February 22, 2021

Re: Comments of Horizon West Transmission, LLC on the Draft Environmental Impact Report for the Estrella Substation and Paso Robles Area Reinforcement Project, December 2020 (California State Clearinghouse No. 2018072071)

Figure 2-11.
Preliminary Substation Layout
Estrella Substation and Paso Robles Area Reinforcement Project

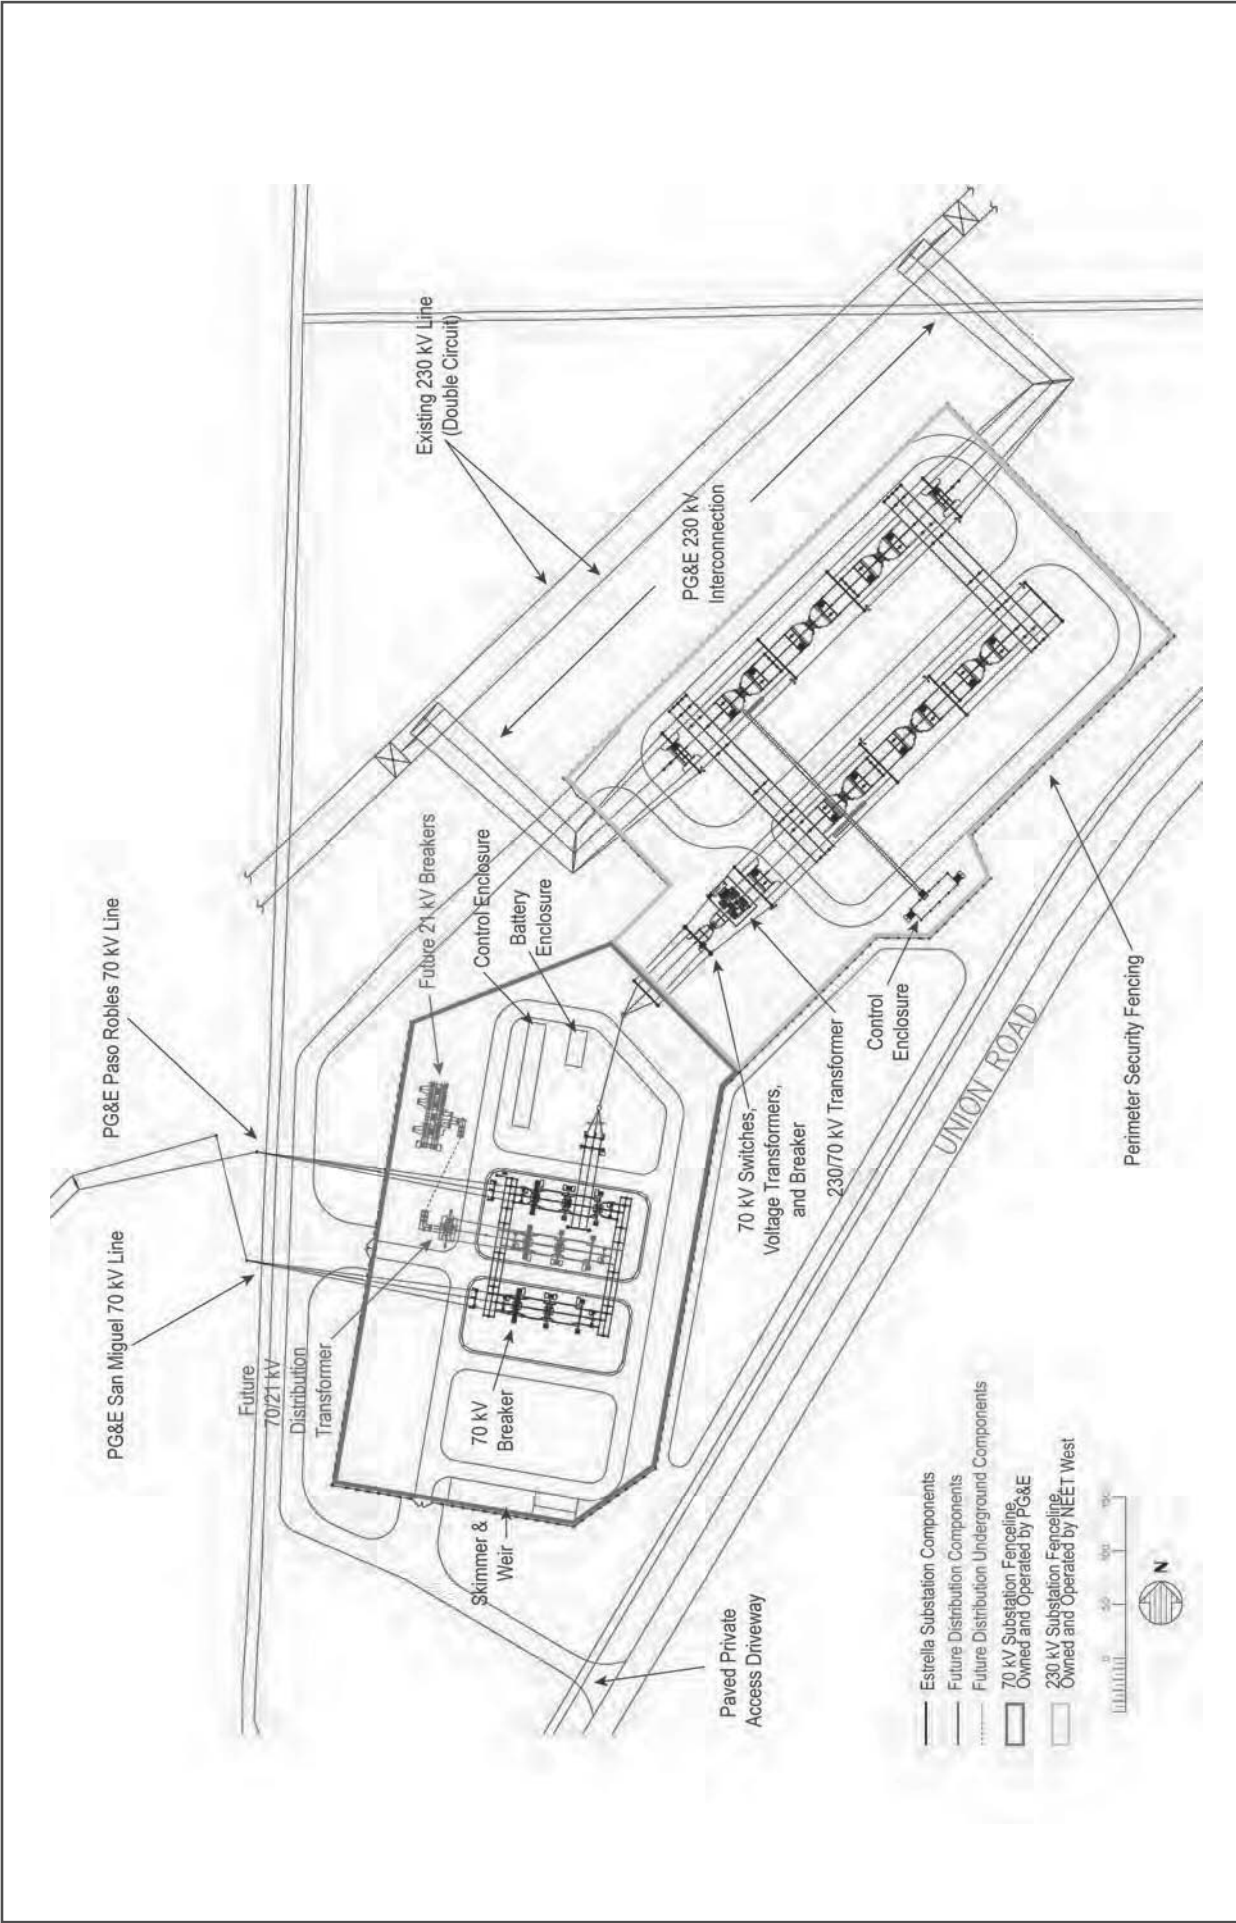
| Page # | DEIR Language | Horizon West Transmission Comments |
|--------|--|--|
| 2-46 | Figure 2-11 | Replace figure with new substation layout |

Figure 2-12.
Proposed 230 Kilovolt Substation General Arrangement

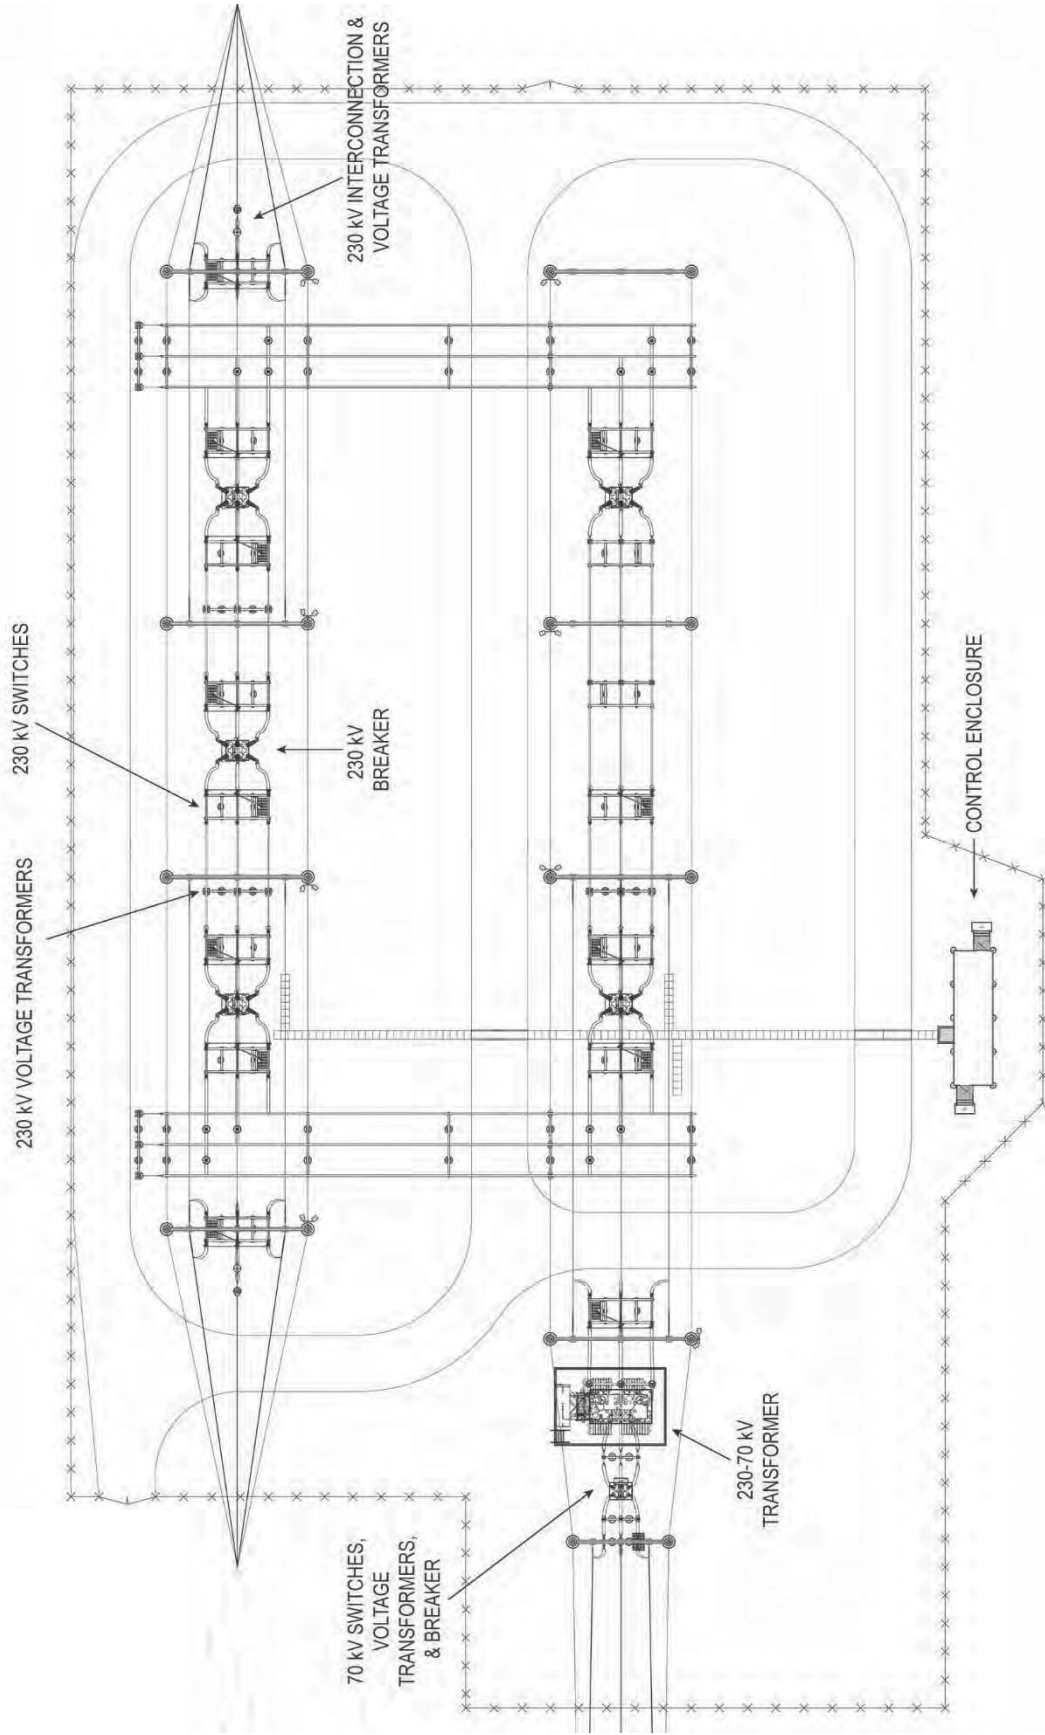
| Page # | DEIR Language | Horizon West Transmission Comments |
|--------|--|--|
| 2-47 | Figure 2-12 | Replace figure with new substation layout |

Figure 2-13.
 Proposed 230 Kilovolt Substation Profile View
 Estrella Substation and Paso Robles Area
 Reinforcement Project

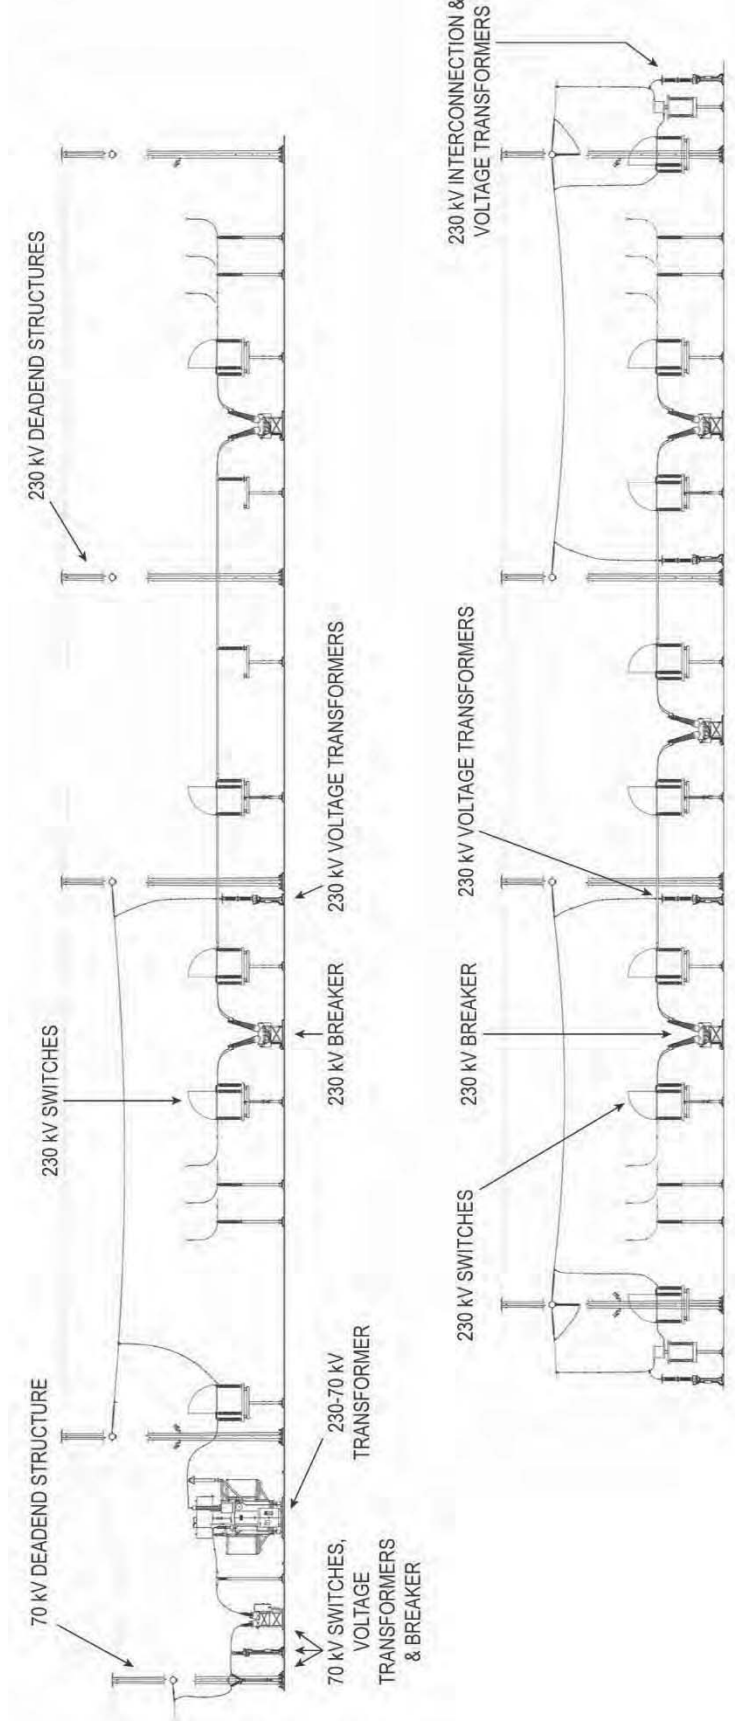
| Page # | DEIR Language | Horizon West Transmission Comments |
|--------|--|--|
| 2-48 | Figure 2-13 | Replace figure with new substation layout |

Figure 2-18.
Ultimate Substation Buildout
Estrella Substation and Paso Robles Area
Reinforcement Project

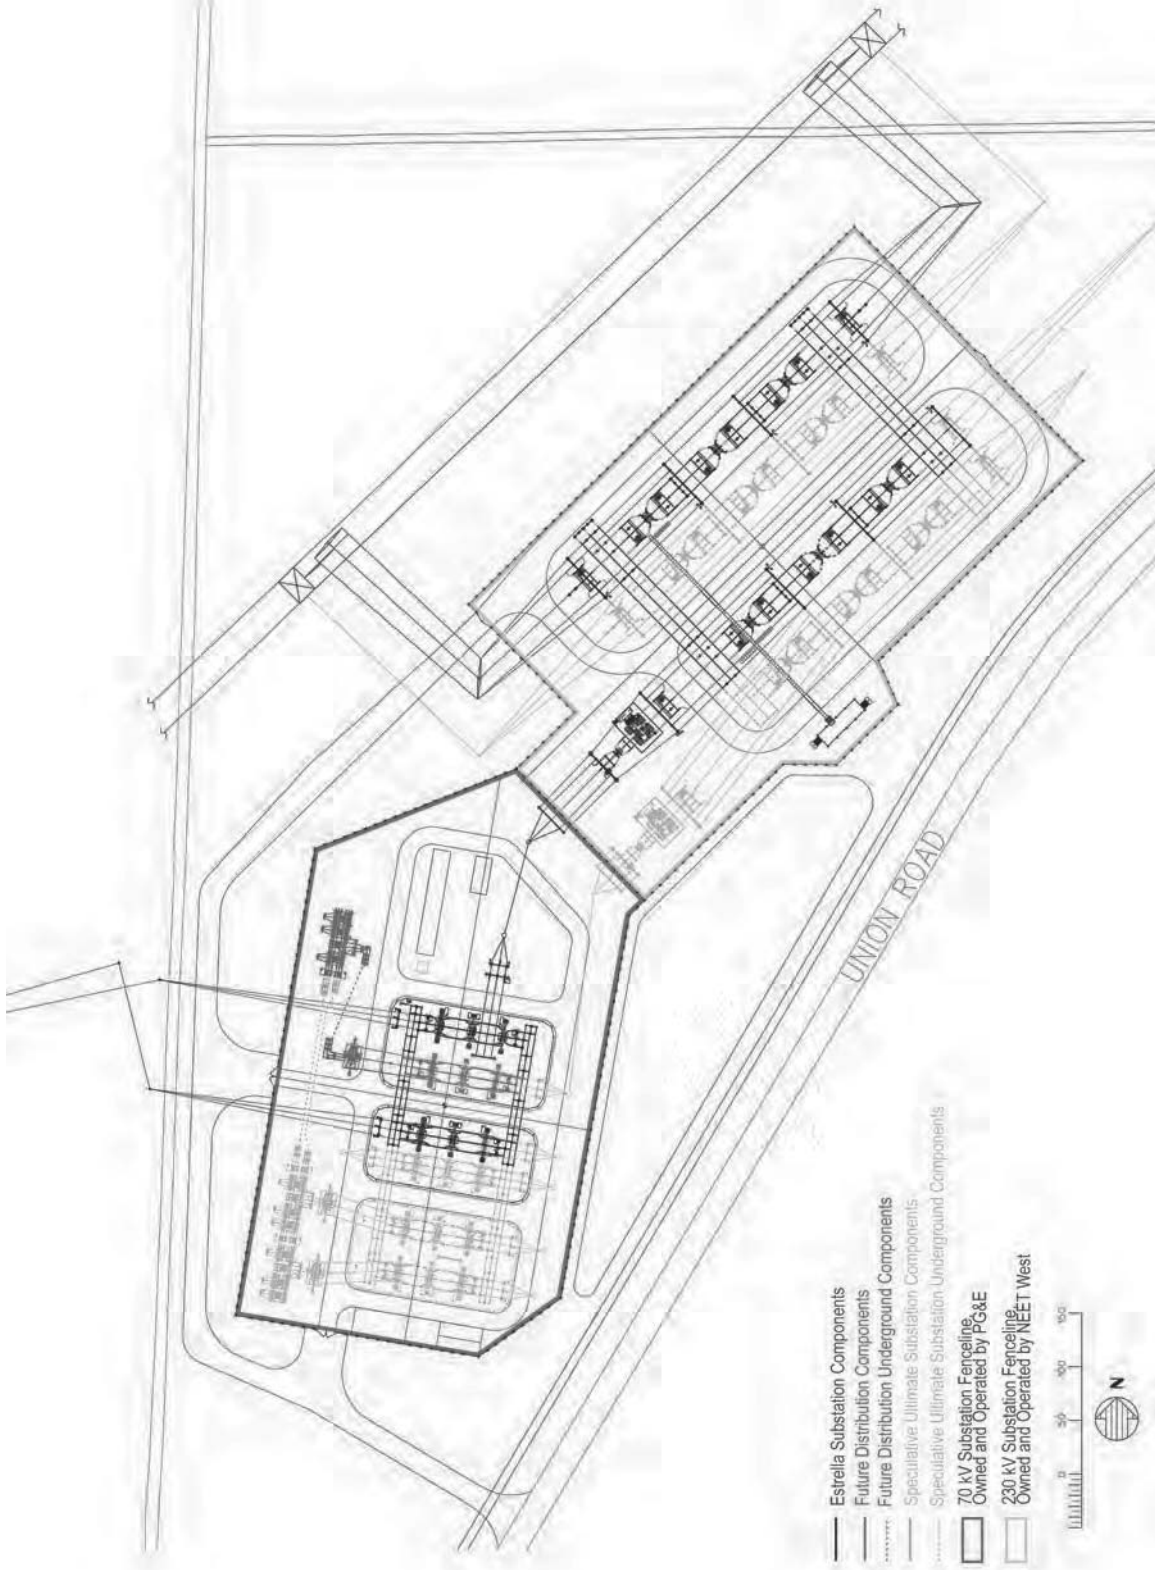
| Page # | DEIR Language | Horizon West Transmission Comments |
|-------------|---|---|
| 2-59 | Figure 2-18 | Replace figure with new substation layout |
